UNITED STATES PATENT AND TRADEMARK OFFICE

APPLICATION NO.	FILING DATE	FIRST NAMED INVENTOR	ATTORNEY DOCKET NO.	CONFIRMATION NO.
10/042,829	01/08/2002	Chi Wah Cheng	P/4076-10	7316
2352 7590 11/19/2003				
OSTROLENK FABER GERB & SOFFEN 1180 AVENUE OF THE AMERICAS NEW YORK, NY 100368403				
EXAMINER STONER, KILEY SHAWN				
ART UNIT 1725		PAPER NUMBER

Office Action Summary	Application No.		Applicant(s)	
	10/042,829		CHENG ET AL.	
	Examiner		Art Unit	
	Kiley Stoner		1725

DETAILED ACTION

FIG. 4

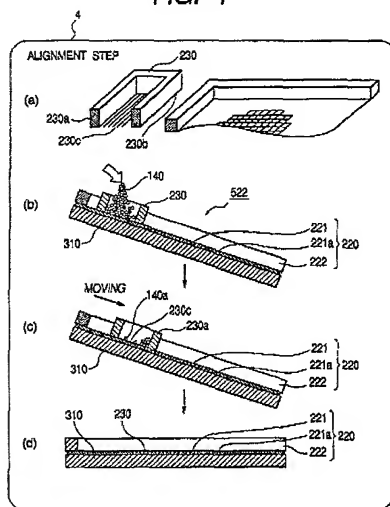
In Figure 4, Ooroku et al. teaches tilting means adapted to rotate the container about an axis perpendicular to the direction of motion of the container to thereby tilt it. The mechanism used to tilt the container of Ooroku et al. is capable of rotating the container and the positioning means a plurality of times when the container is in position directly over the positioning means.

FIG. 5

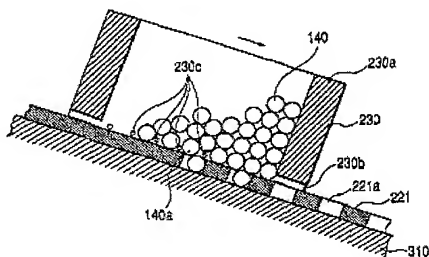
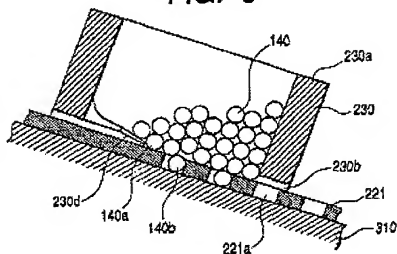
In addition Ooroku et al. teaches the rotational angles of the container and/or the moving speed of the container are controllable to optimize efficiency (column 9, lines 33-38 and column 10, lines 47-65); and the plurality of apertures are located substantially toward one end of the positioning member whereby the container is in communication with the apertures on the positioning member only while the container is in the vicinity of the second position (Figures 5-6).

FIG. 9

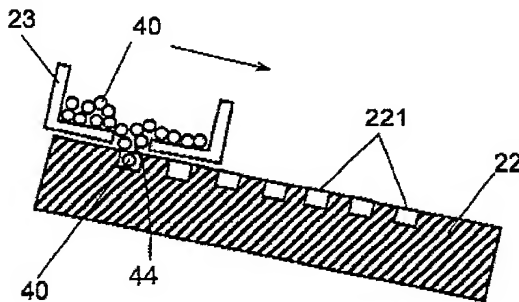
Kasai et al. teaches a guide member which is configured to direct the solder balls to positions corresponding to the array of positions the solder balls are to take up on the substrate (Figure 9, specifically #22); a container for a plurality of solder balls, the container being movable between a first position remote from the guide member and a

second positioned directly in communication with the guide member (Figure 9, specifically #23); a mechanism configured to apply a force to the solder balls in the container in the direction of movement of the container as the container moves between the first position to the second position (Figure 9). On page 4, lines 5-9 and page 7, lines 1-19 of the specification the applicant uses a gravitational force and the force generated by the walls of the container during movement to bias the solder balls in the direction of movement of the container. The mechanism that Kasai et al. uses to move the container #23 applies force to the solder balls through both gravity and the side walls of the container #23. Figure 9 also teaches tilting means adapted to rotate the container about an axis perpendicular to the direction of motion of the container to thereby tilt it. The mechanism used to tilt the container of Kasai et al. is capable of rotating the container and the positioning means a plurality of times when the container is in position directly over the positioning means; In addition Kasai et al. teaches the rotational angles of the container and/or the moving speed of the container are controllable to optimize efficiency (column 5, lines 35-46); a positioning rail and motor whereby the motion of the container is guided and driven (column 4, lines 3-9 and column 5, lines 35-46); a vibration-generating device to facilitate the separation of solder balls from surfaces they are in contact with and/or from one another (column 5, lines 21-27); the positioning means includes a ball template with a plurality of apertures each slightly larger than the size of a solder ball in order to capture solder balls with in the template, and wherein the plurality of apertures are arranged in an order similar to the array positions comprising solder pads on the substrate; solder balls captured in the
